Access Compliance Report

Public Rights-of-Way

Intersection ID: 16763	Main Street: BUCKNELL_AV	Cross Street: HASTINGS_DR	Location: NW
ADA ID: 8F25B4659B54	Ramp Type: Perpendicular Diagonal	Initial Pass/Fail: Pass	Overall Compliance: No
		Severity Score: 10

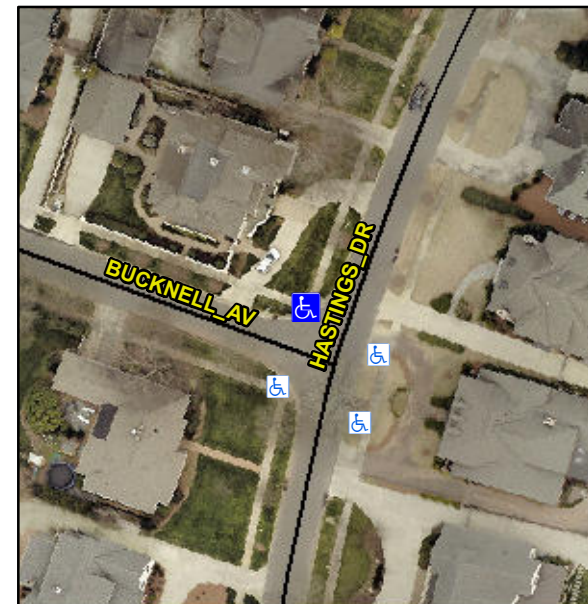
Not Found, R304.2.1, R304.2.2-Perp, R304.3.2-Para, R304.5.3, R305.2

Compliance	Description	Data	Compliance	Description	Data
N/A	Ramp Length (in)	77.5	Yes	Ramp Slope (%)	6.6
Yes	Ramp Width (in)	48.0	Yes	Ramp XSlope (%)	1.5
N/A	Flare Type LT	Sloped	N/A	Flare Type RT	N/A
N/A	Flare Slope LT (%)	1.7	Yes	Flare Slope RT (%)	2.3
N/A	Flare Traversable LT?	Yes	N/A	Flare Traversable RT?	Yes
No	Landing Length (in)	N/A	Yes	DWS Provided?	Yes
No	Landing Width (in)	N/A	Yes	DWS Contrast?	Yes
No	Landing Slope (%)	N/A	Yes	DWS Length (in)	24.0
No	Landing X Slope (%)	N/A	Yes	DWS Full Width?	Yes
N/A	Landing Curb? (Y/N)	No	No	DWS Offset (in)	3.5
N/A	Shared Landing?	N/A			
Yes	Gutter Ponding?	No	Yes	Gutter Slope (%)	1.2
Yes	Gutter Lip Ht (in)	0.0	Yes	Gutter X Slope (%)	1.4
N/A	Painted X Walk1?	No	N/A	Painted X Walk2?	No
	X Walk 1 Direction	To SW		X Walk 2 Direction	To SE
N/A	X Walk 1 Width (in)	N/A	N/A	X Walk 2 Width (in)	N/A
	X Walk 1 Slope (%)	2.2		X Walk 2 Slope (%)	2.6
	X Walk 1 X Slope (%)	0.6		X Walk 2 X Slope (%)	1.1

Remove & Replace Curb Ramp With Two New Directional Ramps or Equivalent.
